# Regulatory Analysis Form

(4) Short Title:  
Revised Total Coliform Rule (RTCR)

**COMMENT AND RESPONSE  
DOCUMENT**

**REVISED TOTAL COLIFORM RULE  
(RTCR)**

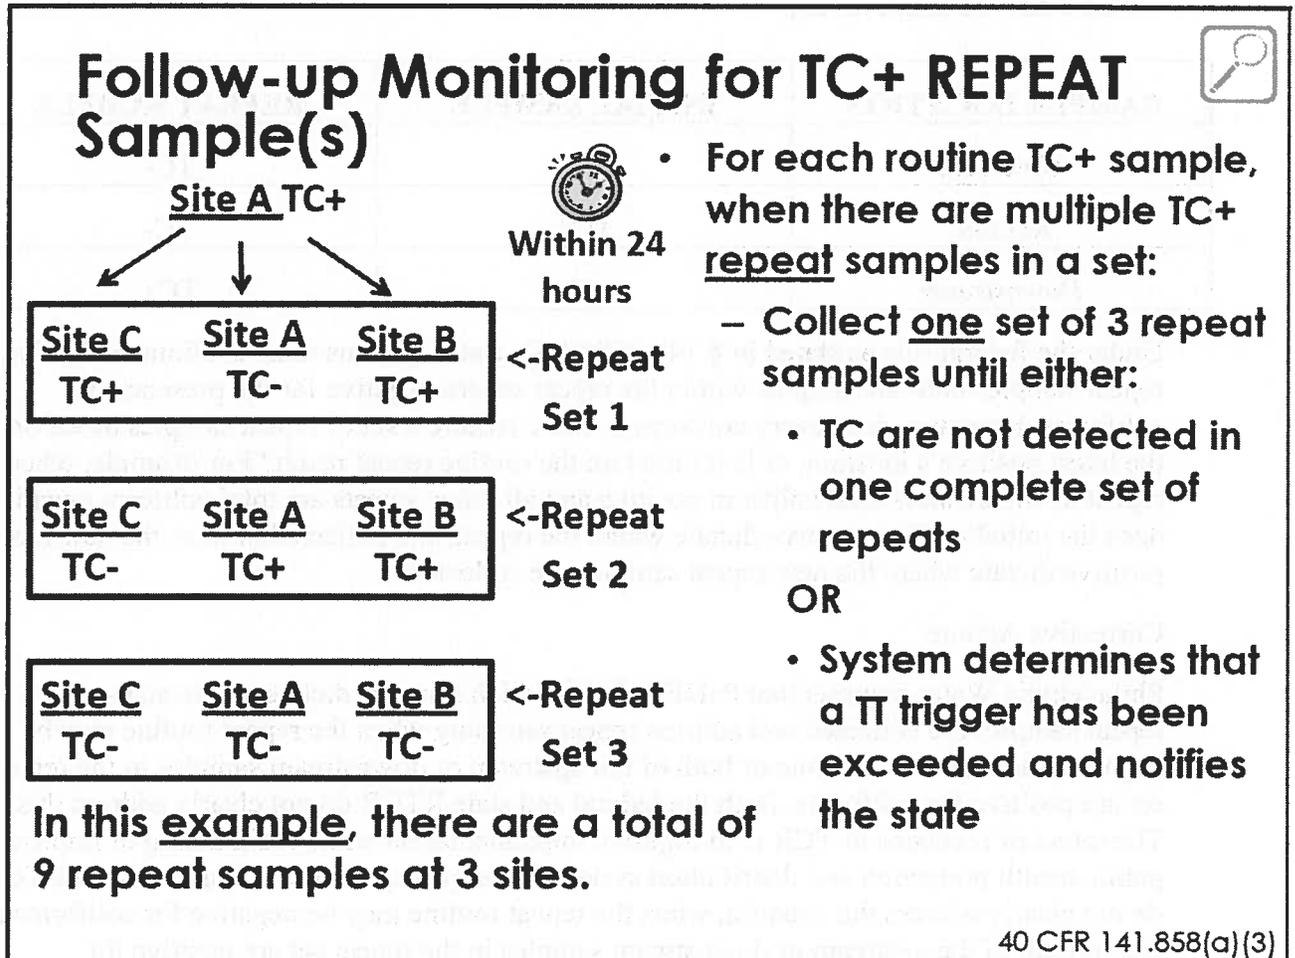
Philadelphia Water requests that PaDEP clarify which samples dictate where subsequent repeat samples are collected and address repeat sampling when the repeat routine may be negative for coliforms but one or both of the upstream or downstream samples in the repeat set are positive for coliforms. Both the federal and state RTCR do not clearly address this. The intent of revisions to TCR is to improve implementation while maintaining or improving public health protection and distribution system water quality. If the federal and state RTCR do not clearly address the situation when the repeat routine may be negative for coliforms but one or both of the upstream or downstream samples in the repeat set are positive for coliforms, then public health protection will be weakened. (4)

The Department has revised § 109.301(3)(ii)(D) to show that systems must continue to conduct repeat monitoring from the same three locations in the original set of check samples as follows:
